**POLARIS****TECHNICAL SERVICE BULLETIN**

Bulletin Number: A-17-01-C

SUBJECT:**2015–2016 Sportsman 850 1-Up Thermal Protection Update****PURPOSE:**

Some model year 2015–2016 Sportsman 850 1-Up models were manufactured with an exhaust manifold side panel that may contact the exhaust manifold. The resulting contact between the exhaust manifold side panel and exhaust may pose a fire hazard.

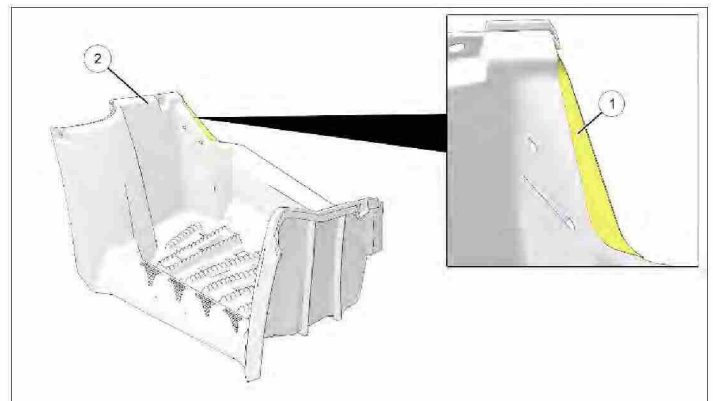
2. Place the provided template ① on the right-hand footwell ② as shown, then mark the perimeter of the template to outline the area to be trimmed with a paint pen.

Use the inside and back edges of the footwell to locate the template.

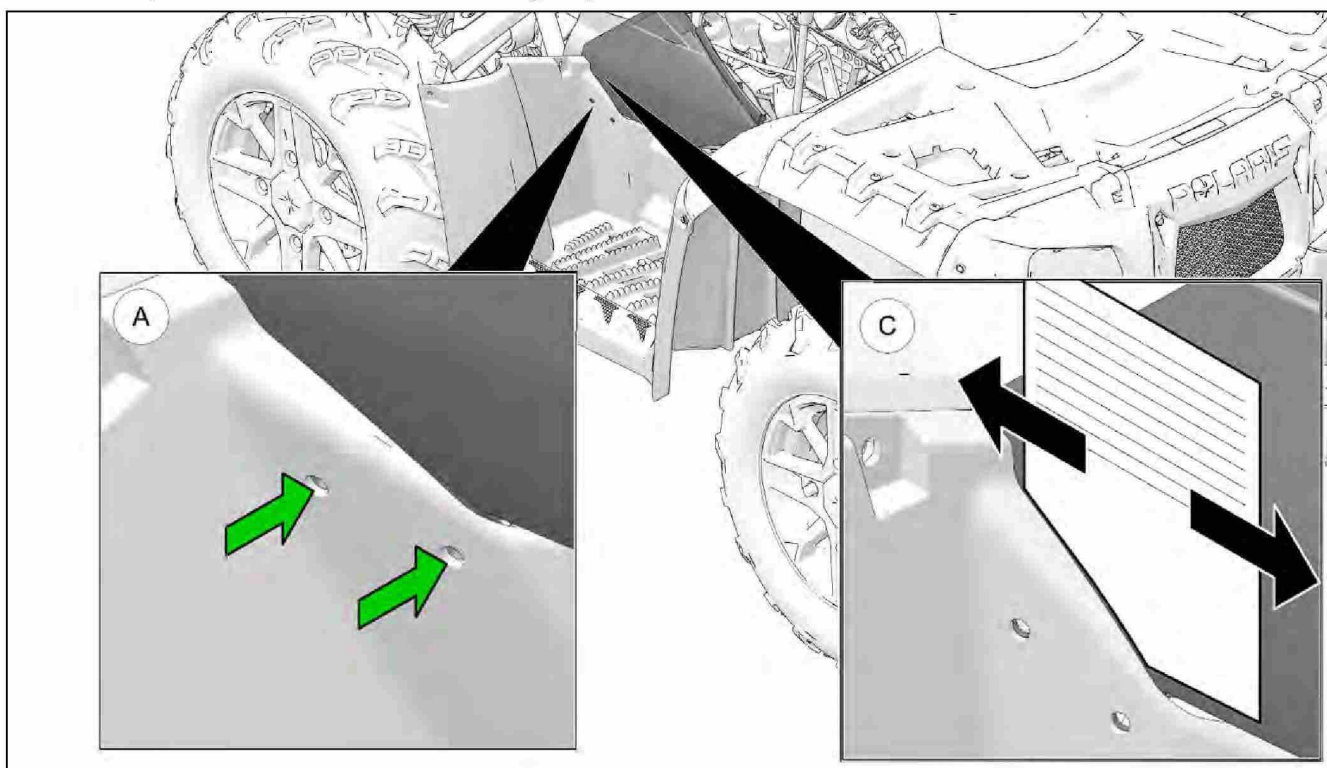
5. Using a DREMEL® with a two flute bit intended for plastics, a reciprocating saw or similar device, trim the footwell corner in line with the template (area circled in red shown in the **Before** and **After** images below).

6. Test fit the new panel to verify the footwell area trimmed does not contact the exhaust manifold side panel when the lower mounting surface is contacting the footwell.
- Align the mounting holes.
 - Press the exhaust manifold side panel against the footwell applying pressure at or near the holes.
 - Slide a piece of paper along the gap between the two panels.
 - If the paper slows or stops or the metal shield makes contact with the footwell, use a half-round file to trim the footwell to create a clearance gap between the components.
 - If the paper freely travels the length of the gap, and the metal shield does not contact the footwell, proceed to the audit and following steps.

Before

After

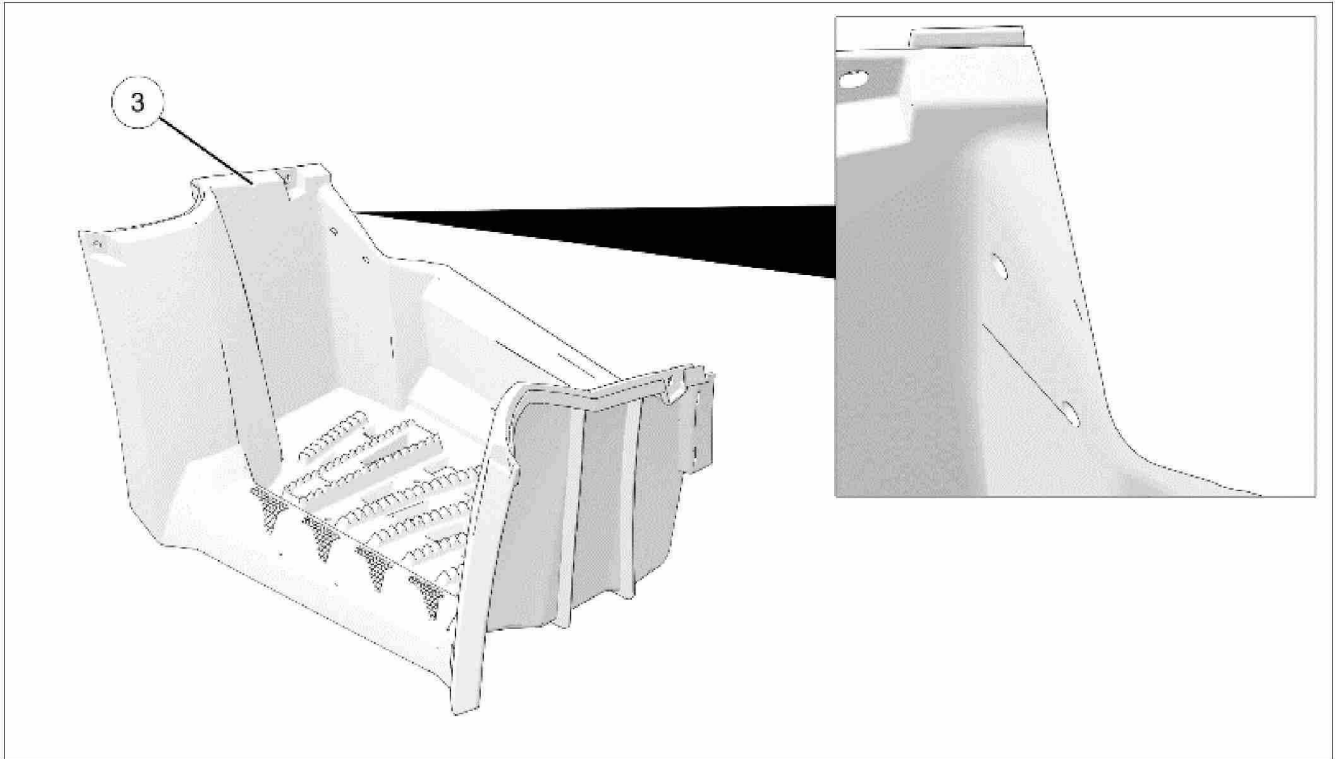
A secondary dealer representative must verify that the trimmed edge of the footwell does not contact the new exhaust manifold side panel.

If a piece of paper does not freely slide between the panels, continue to trim the panel using a half round file until the paper passes freely the entire length of the gap.

7. Using a half-round file, file and deburr the trimmed footwell ③. Ensure the footwell is clean, free of burrs, and maintains rider appeal. Verify trimmed area appears as shown in the illustration below.

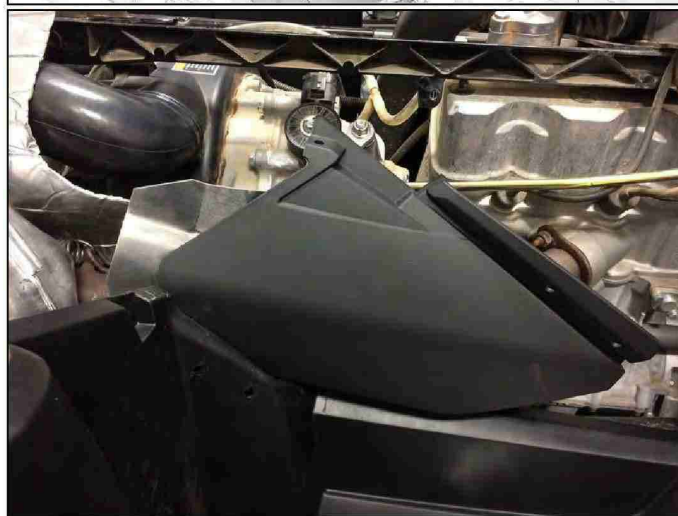
5. Pull the upper rear of the footwell towards the right side of the vehicle, then slide the NEW exhaust manifold side panel (2636626) along the head pipe and release the footwell.

A secondary dealer representative must verify the new exhaust manifold side panel (2636626) has been installed and the exhaust manifold side panel has been discarded.

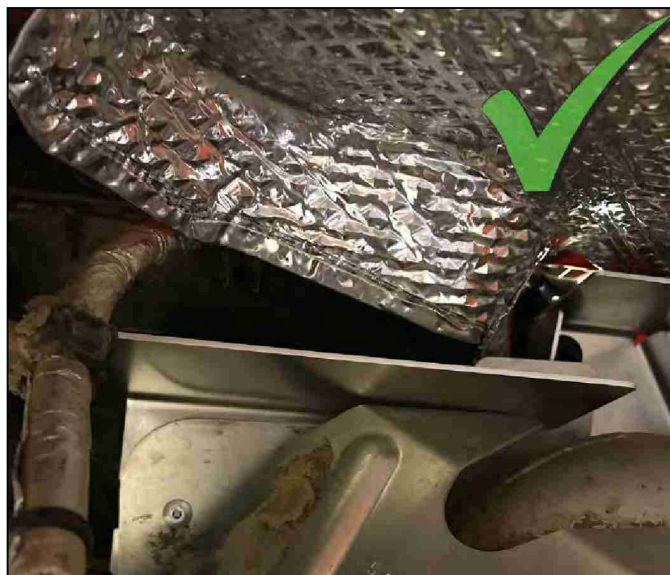
A secondary dealer representative must verify the Rear Cab Heat Shield is bent down and wraps around the corner of the Storage Box and Tail Light Harness. If it interferes when installing the cab, ensure it is bent back down to match the good example below.

Acceptable – Rear Cab Heat Shield wraps around the corner of the storage box and harness

Unacceptable – Rear Cab Heat Shield interferes with the storage box and harness
